98-104 BAXTER BOULEVARD

ALTERATIONS TO THE GULICK RESIDENCE
102 Baxter Boulevard Portland, Me.

ADDENDUM I

OUTLINE SPECIFICATIONS

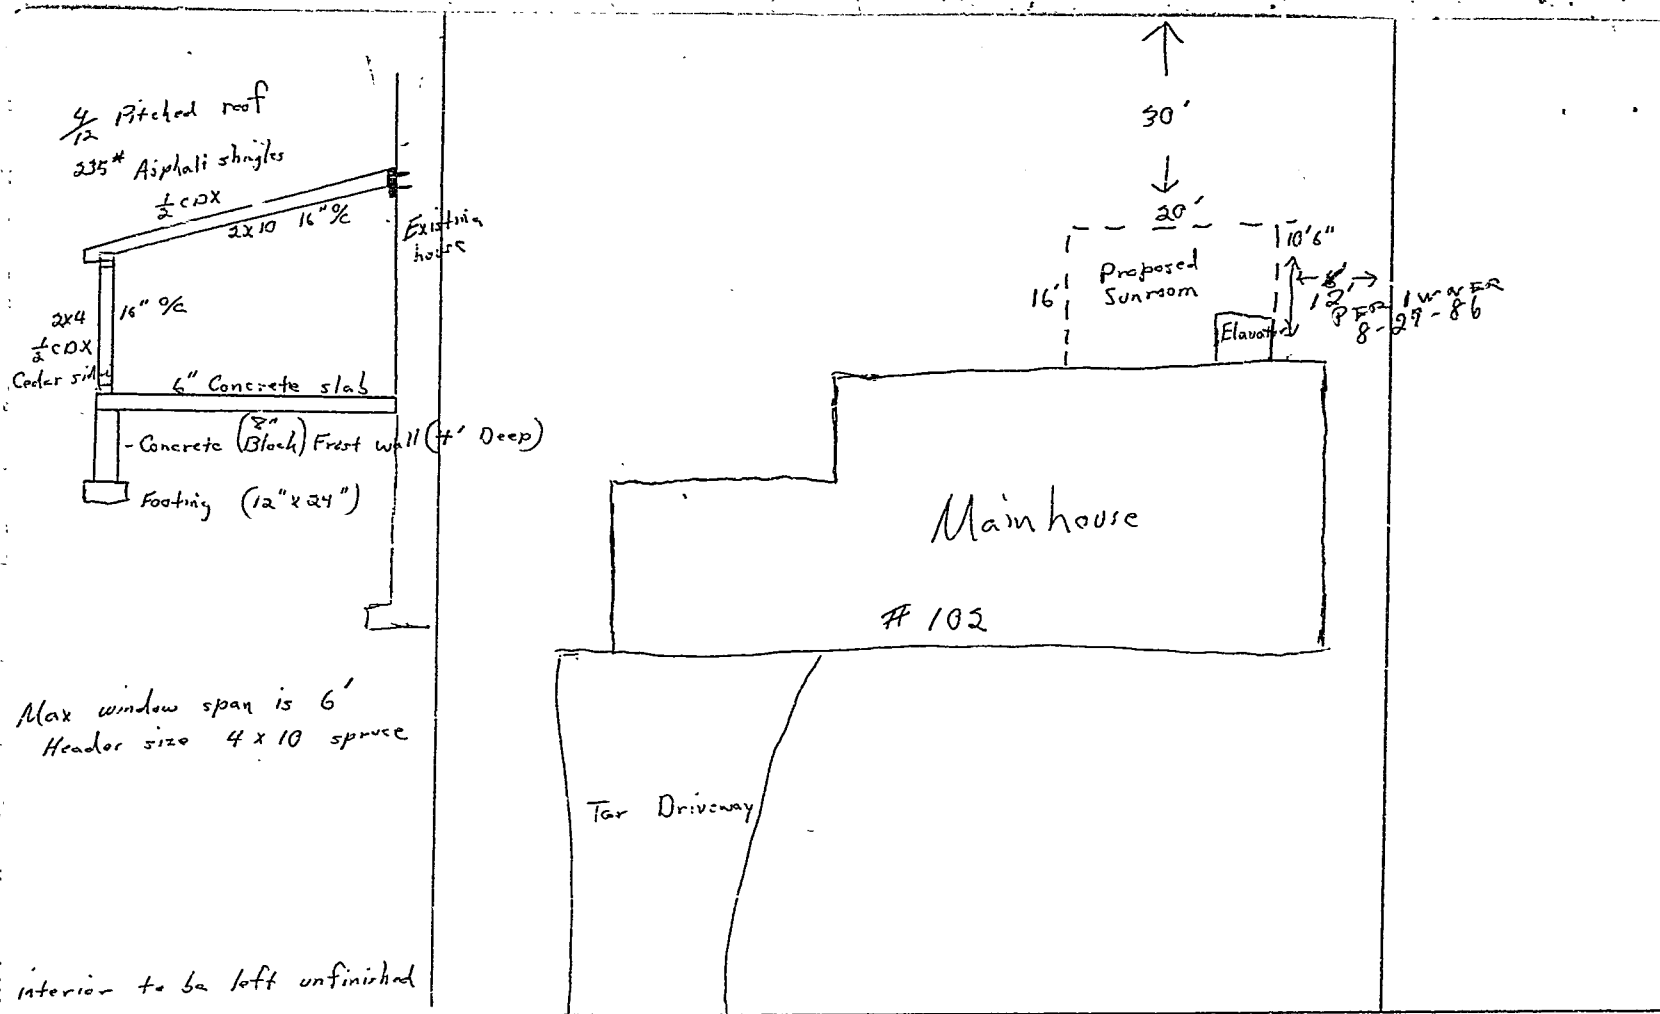
A building permit for the proposed addition to your residence at 102 Baxter Boulevard can not be issued due to the side yard setback which your plot plan shows as 6 feet. The Zoning Ordinance for the R-5 Residence Zone requires a side yard setback of 8 feet for a one or one and a half story building. Therefore the proposed sunroom addition must be also 8 feet from the side line of your property. This is a minimum side yard setback.

Do you wish to amend your plan to show this change in the side yard measurement? Or do you wish to file an appeal before the Board of Appeals? The forms for this request are enclosed for your information.
